DEVELOPMENT ASSESSMENT REPORT	
<b>Application No.</b>	REV/2021/0009
<b>Address</b>	7 Westbourne Street STANMORE NSW 2048
<b>Proposal</b>	S8.2 Review Application of DA/2020/0827 for demolition of existing building, Torrens Title Subdivision of existing lot into 2 lots, construction of a semi-detached dwelling with a secondary dwelling and garage to each lot. Landscaping and associated works.
<b>Date of Lodgement</b>	30 April 2021
<b>Applicant</b>	Urban Future Organisation
<b>Owner</b>	Grey Gum Investments Pty Ltd
<b>Number of Submissions</b>	Initial: 2
<b>Value of works</b>	\$961,941.00
<b>Reason for determination at Planning Panel</b>	Recommendation of refusal of Section 8.2 application
<b>Main Issues</b>	<ul style="list-style-type: none"> <li>• Solar access to private open space of proposed dwellings.</li> <li>• Building height, bulk, scale and setbacks.</li> <li>• Streetscape</li> <li>• Appropriateness of subdivision and replacement dwellings.</li> </ul>

<b>Recommendation</b>	Refusal
<b>Attachment A</b>	Reasons for refusal
<b>Attachment B</b>	Plans of proposed development
<b>Attachment C</b>	Without prejudice conditions if consent is granted
<b>Attachment D</b>	Reasons for refus

PROPOSED SHADOW DIAGRAM  
21 JUNE - 09:00 AM TO 10:00 AM

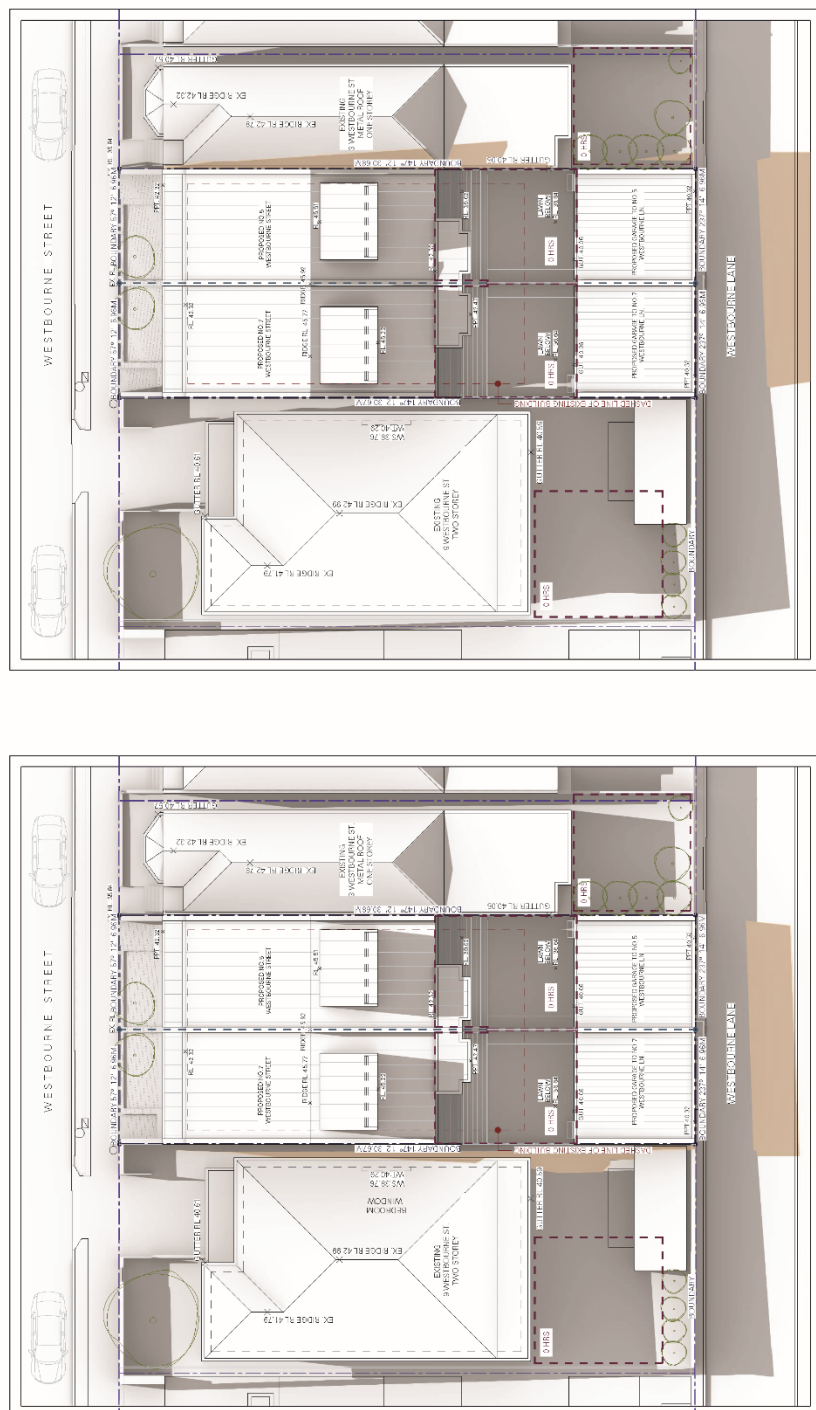
Elevational and plan shadow diagrams were submitted for June 21<sup>st</sup> and the March/September equinox. An assessment of the proposal against Control 2 is provided below.

The indicative shadow diagrams demonstrate that a 900mm side setback does result in additional solar access being provided to the POS of each dwelling. As such, it has been demonstrated that despite the orientation of the site, alternative designs can provide increased solar access and enhanced amenity on the site.
